SUNDRY NOTICES AND REPORTS ON WELLS

☐ Oil Well ☒ Gas Well ☐ Other8. Well Name and No.
DIAMOND AKI FED 2

30-015-29125-00-S1

Yates Petroleum Corporation plans to plug and abandon this well as follows:

After

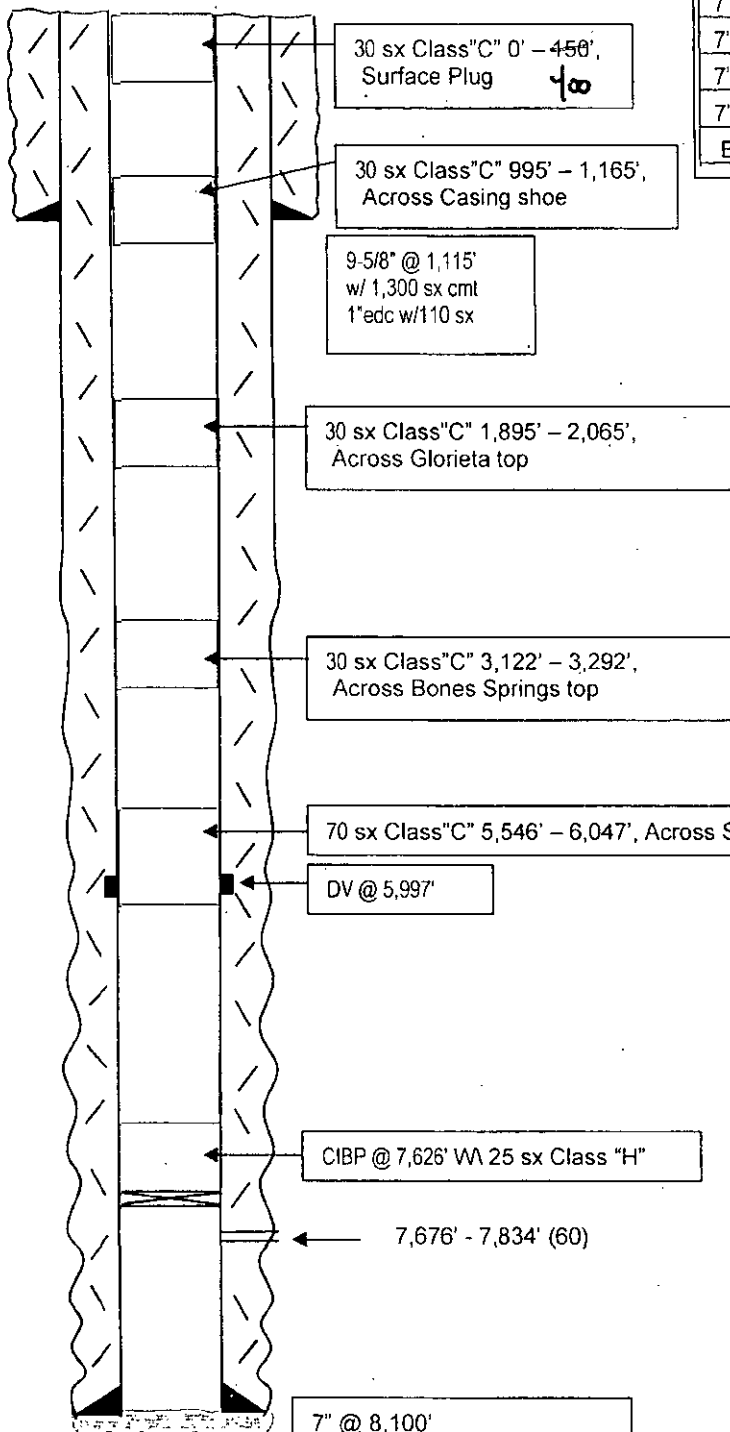
** BLM REVISED ** BLM REVISED ** BLM REVISED ** BLM REVISED ** BLM REVISED **

7. Set a 30 sx Class C cement plug from 0 - ~~150~~⁴⁰⁰ ft. This will form the surface plug. WOC and tag, reset if necessary.

30 sx Class "C" 0' - 450',
Surface Plug
